Subject: Application for Licensee Proposed Modification to the Generation License under NEPRA Licensing (Application, Modification, Extension and Cancellation) Procedure Regulations, 2021, on behalf of 2x660 MW Thar Coal Block-1 Power Generation Company (Private) Limited

APPLICATION FOR MODIFICATION OF
GENERATION LICENSE NO. IGSP/L/74/2017 DATED JANUARY 05, 2017

THAR COAL BLOCK-1 POWER GENERATION COMPANY
(PRIVATE) LIMITED

(a). Single Line Diagram of Thar Coal Block-1 Power Generation Facility

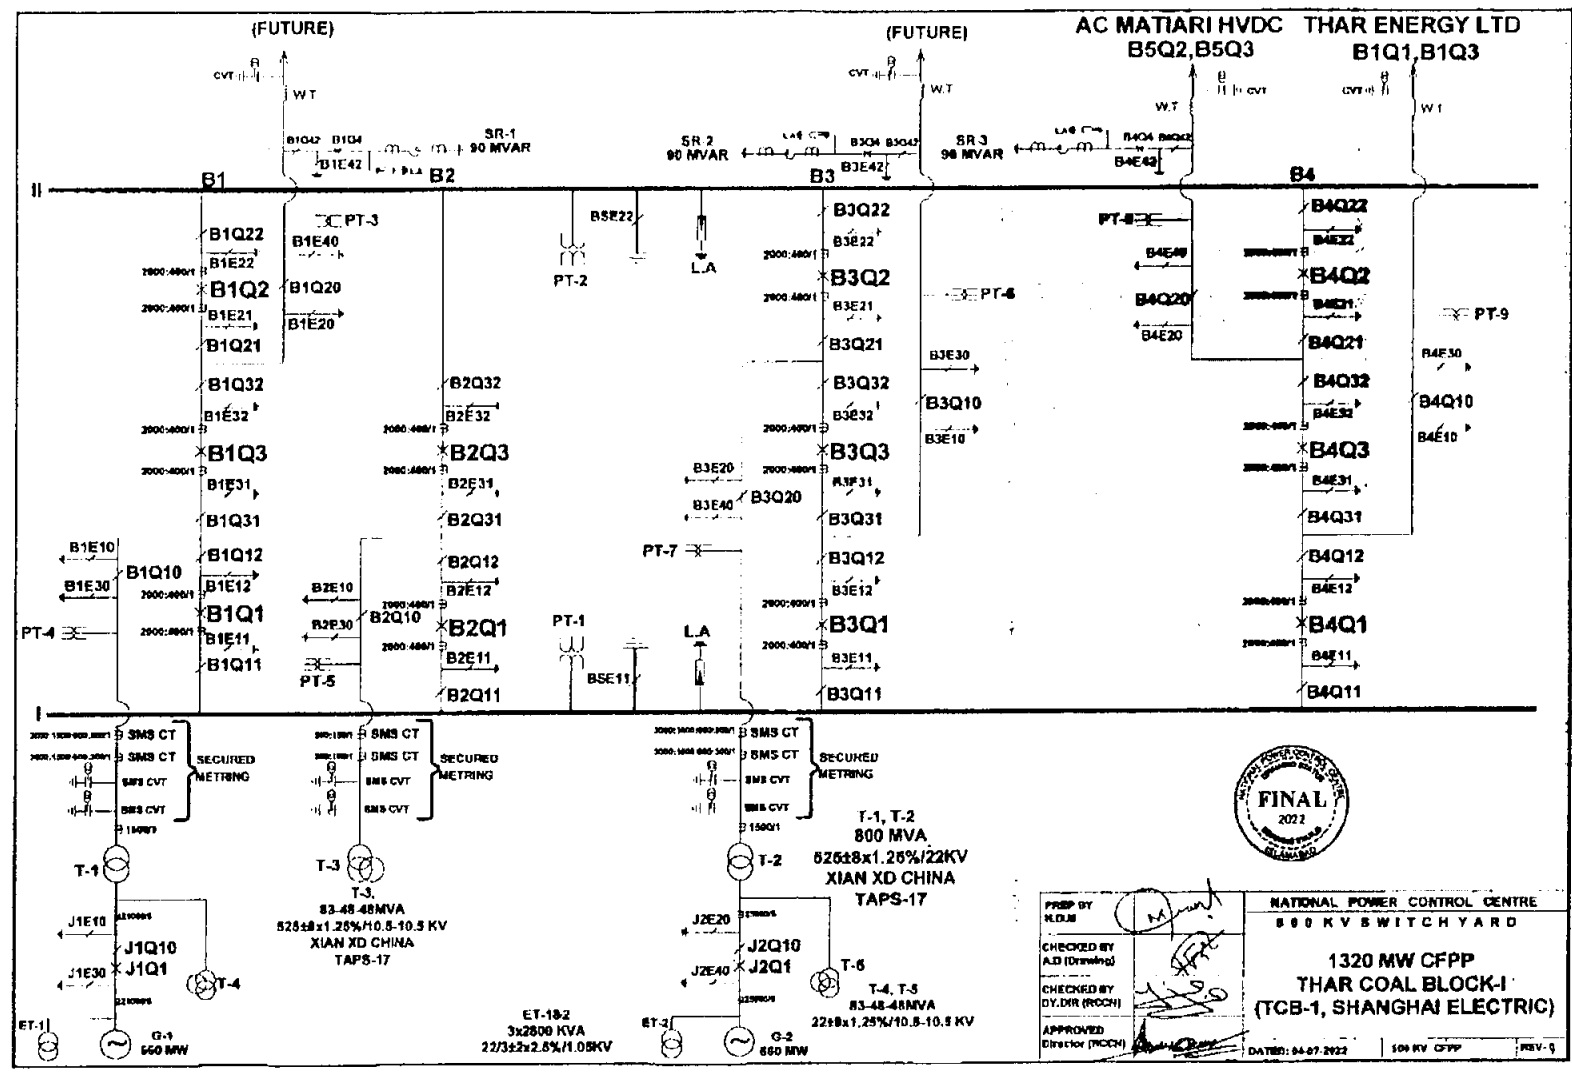
NPCC has approved the finalized SLD of TCB-1 Project as per the latest interconnection and power dispersal scheme. Therefore, the updated SLD has been attached in this LPM for its revision in the Generation License.

Schematic Diagram
of Interconnection Arrangement for Dispersal of Power from the Generation
Facility / Thermal Power Plant

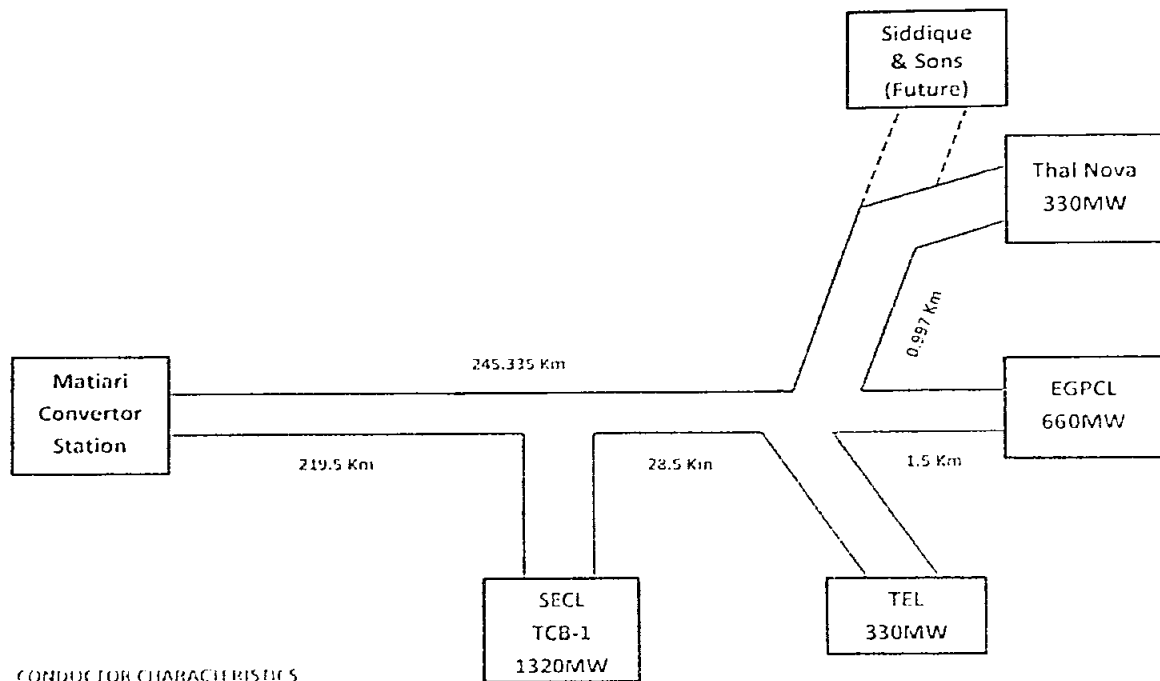
(b). Interconnection Facilities/Transmission Arrangements for Dispersal of Power from the Generation Facility/Thermal Power Plant:

The para (2) in the original Generation License under the narrated heading, is hereby proposed to be modified with the following, while the other paras remain the same. i.e.,

NTDC has revised the whole scheme of interconnection facilities for that region. Therefore, the Power Purchaser Interconnection Facilities for TCB-1 Project has also been revised which were not envisaged at the time of application/grant of Generation License. Therefore, the updated interconnection facilities have been attached in this LPM for its revision in the Generation License.

“The Interconnection Facilities (IF)/Transmission Arrangement (TA) for supplying to National Grid from the above-mentioned generation facility shall be at 500 kV voltage level. The Interconnection/Dispersal Arrangement will be consisting of a 500 kV triple circuit transmission line connecting the Power Plant directly with Matiari Converter Station, while the fourth circuit will be connected with 330 MW TEL Power Plant through in/out arrangement. ”
